ENQUIRY RESULTS

<p>prEN 50549-2 Title: Requirements for generating plants to be connected in parallel with distribution networks - Part 2: Connection to a MV distribution network</p>	<p>Submission: 2017-05-26 Deadline: 2017-08-18 Subsector: U95 Project: 63321 TC(s): CLC/TC 8X Directive(s): RfG (2016/631) Mandated: M/490 Supersedes: CLC/TS 50549-2:2015</p>
---	---

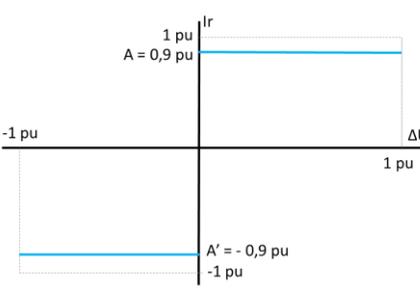
AT 28	0998	4.7.3.2.1	Figure 16	technical	The upper tolerance limit in quadrant 2 is set with $k = 6$. This means that if the actual set value for k is 6, which can happen because the configurable range for k_1 and k_2 is 2-6, there is no tolerance range.	Change the upper limit of tolerance range in quadrant 2 to $k = k_{set}$.	rejected comment is not correct, $k=6$ is the gradient of the tolerance line, however the tolerance line is still 20% shifted above the set value. A tolerance of 20% is present also for $k=6$	3

Bild C.3 – Veranschaulichung bei $3 \tau = 10 \text{ s}$

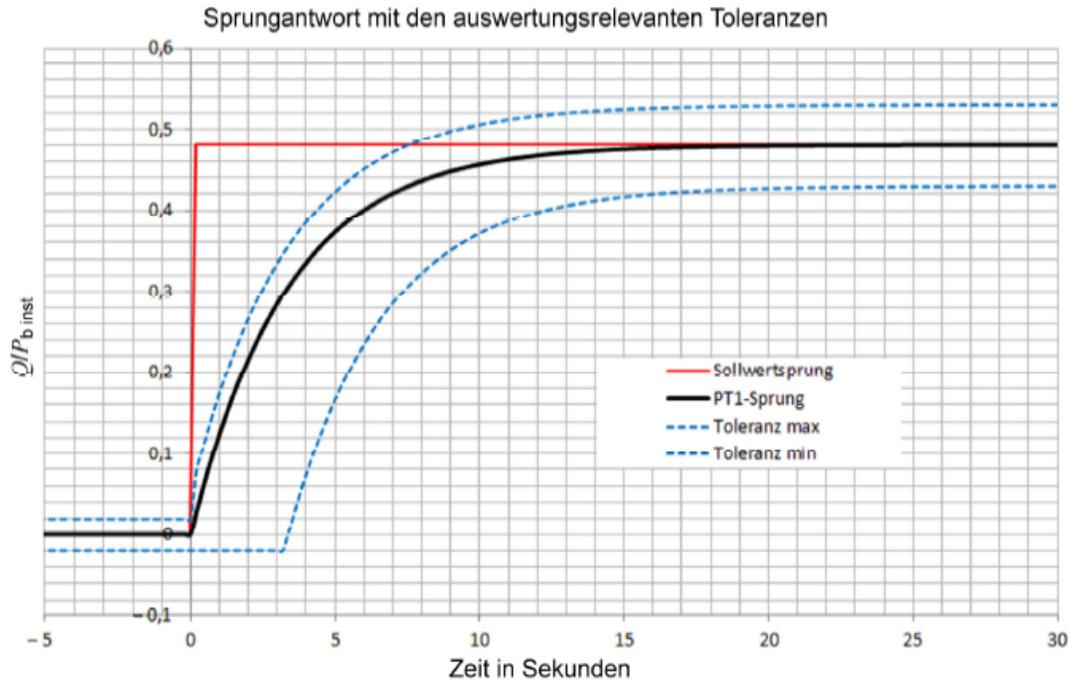
Annex to DE-079:

The tolerance in time shall be $-0/+3\text{sec}$ or $-0/+2*\tau$, whatever is the larger. The tolerance of Q during dynamic operation shall be: $\pm 10\%$ of S_n .
